Service Letter No. 417

SUBJECT: Replacement of Fuel Injector Inlet Screens

MODELS AFFECTED: PA-30 Twin Comanches, Serial No. 30-1 to 30-179 incl.
30-180 right engine only
30-181 left engine only
30-202 right engine only
30-220 right engine only

Service Letter 417

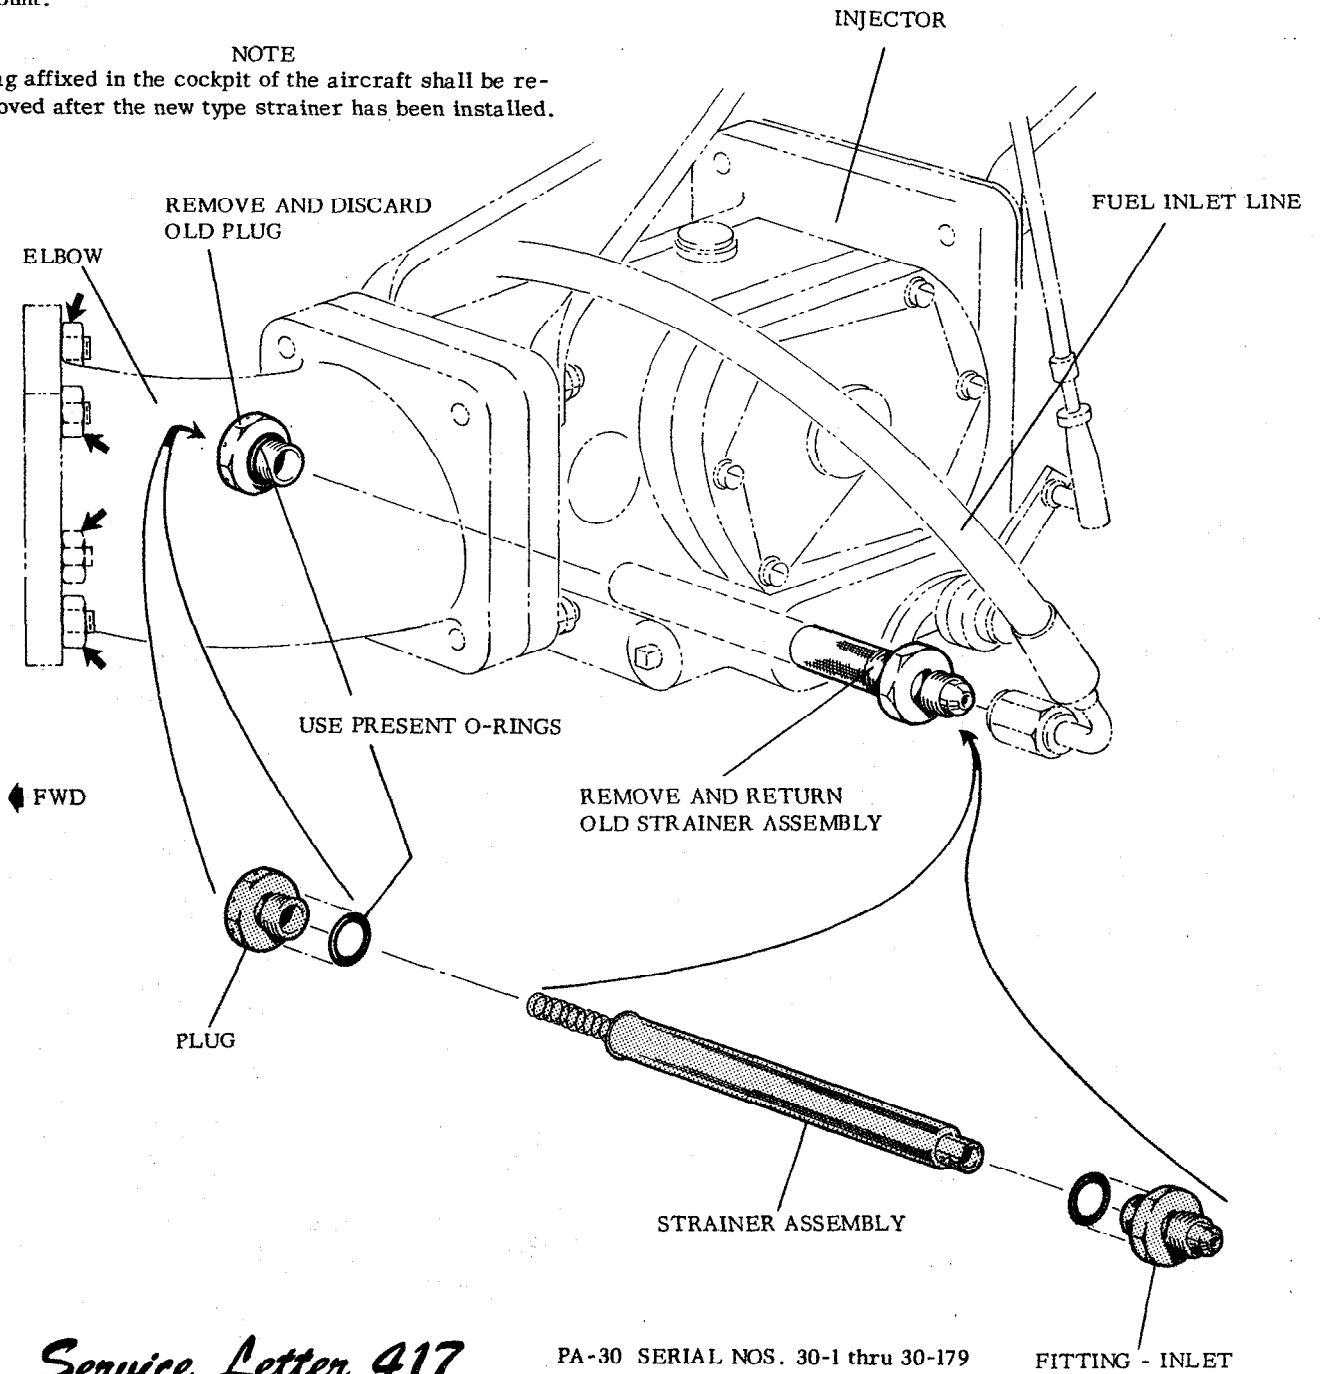
A fuel injector inlet screen replacement kit, part number 756 782, consisting of two fuel inlet fittings, two strainer assemblies and two plugs, which will facilitate removal and installation, is now available and shall be installed at or before the next 100 hour inspection in accordance with the sketch on the reverse side of this letter.

Loosen the four nuts holding the 45° injector turning elbow to the engine oil sump sufficiently to allow the downward rotation of the injector assembly so that the screen assembly will pass freely below the engine mount.

Tag affixed in the cockpit of the aircraft shall be removed after the new type strainer has been installed.
